Project: IEEE P802.15 Working Group for Wireless Personal Area Networks (WPANs)

Submission Title: comment and resolution about CID 59 and etc.

Date Submitted: 9th July, 2010

Purpose: Contribution to IEEE 802.15.7 TG-VLC

CID 64 (Subclause 6.4.1.6, page 42, line 9)

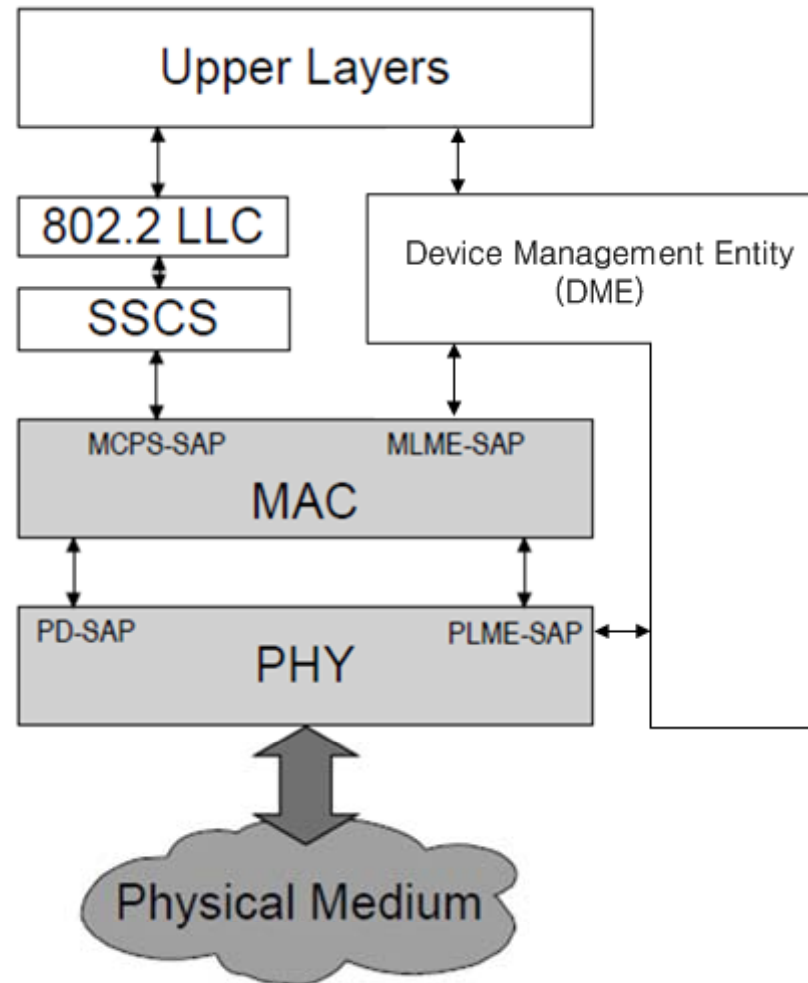
- DME is missing from Figure 3

- Modify figure 3 to include DME

- My suggestion is **Accept**.
- Instruction to editor: insert DME in figure 3. please refer next slide.
